Access Compliance Report

Public Rights-of-Way

(Curb Ramps)

Intersection ID: 31378	Main Street: CARRINGTON_HILL_DR	Cross Street: AUBREYWOOD_DR	Location: W
ADA ID: 5639DB1B631F	Ramp Type: PerpDiag	Initial Pass/Fail: Fail	Overall Compliance: No
Codes/Mitigation Info/Possible Solution		Field Measurements/Component Compliance	
Severity Score: 46.25

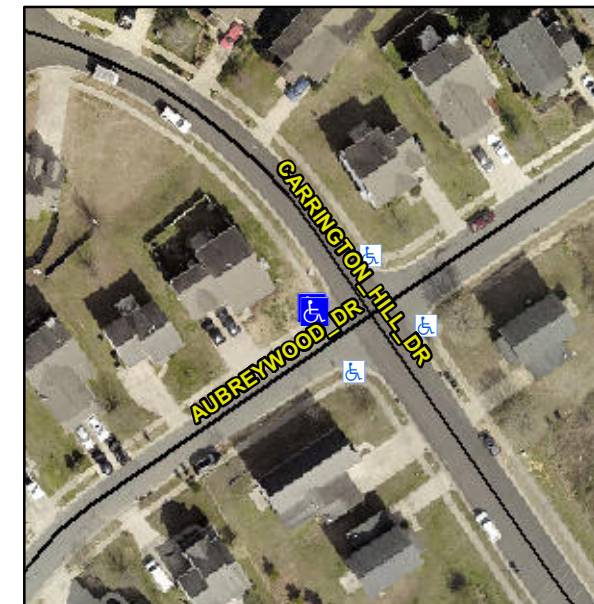
Not Found, R304.5.1, R304.2.2, R304.5.3

Compliance	Description	Data	Compliance	Description	Data
N/A	Ramp Length (in)	48.0	No	Ramp Slope (%)	12.2
No	Ramp Width (in)	40.5	No	Ramp XSlope (%)	6.4
N/A	Flare Type LT	N/A	N/A	Flare Type RT	N/A
N/A	Flare Slope LT (%)	N/A	N/A	Flare Slope RT (%)	N/A
N/A	Flare Traversable LT?	N/A	N/A	Flare Traversable RT?	N/A
N/A	Landing Length (in)	N/A	N/A	DWS Provided?	N/A
N/A	Landing Width (in)	N/A	N/A	DWS Contrast?	N/A
N/A	Landing Slope (%)	N/A	N/A	DWS Length (in)	N/A
N/A	Landing X Slope (%)	N/A	N/A	DWS Full Width?	N/A
N/A	Landing Curb? (Y/N)	N/A	N/A	DWS Offset (in)	N/A
N/A	Shared Landing?	N/A			
N/A	Gutter Ponding?	N/A	N/A	Gutter Slope (%)	N/A
N/A	Gutter Lip Ht (in)	N/A	N/A	Gutter X Slope (%)	N/A
N/A	Painted X Walk1?	No	N/A	Painted X Walk2?	No
	X Walk 1 Direction	To SE		X Walk 2 Direction	To NE
N/A	X Walk 1 Width (in)	N/A	N/A	X Walk 2 Width (in)	N/A
	X Walk 1 Slope (%)	11.9		X Walk 2 Slope (%)	4.1
	X Walk 1 X Slope (%)	0.8		X Walk 2 X Slope (%)	9.6

N/A	Ramp inside XWalk1?	N/A	N/A	Ramp inside XWalk2?	N/A
	Road Slope (%)	4.4	N/A	Clear Space?	N/A
	Road X Slope (%)	9.9	N/A	Clear Space to XWalk (in)	N/A
N/A	Any Obstructions?	N/A	N/A	Storm Grate/Utility Hazard?	N/A
	Obstruction Type			Storm Grate/Utility Type	
		N/A			N/A
			Yes	Surface Condition? (G/P)	Good

Remove & Replace Curb Ramp With Two New Directional Ramps or Equivalent.
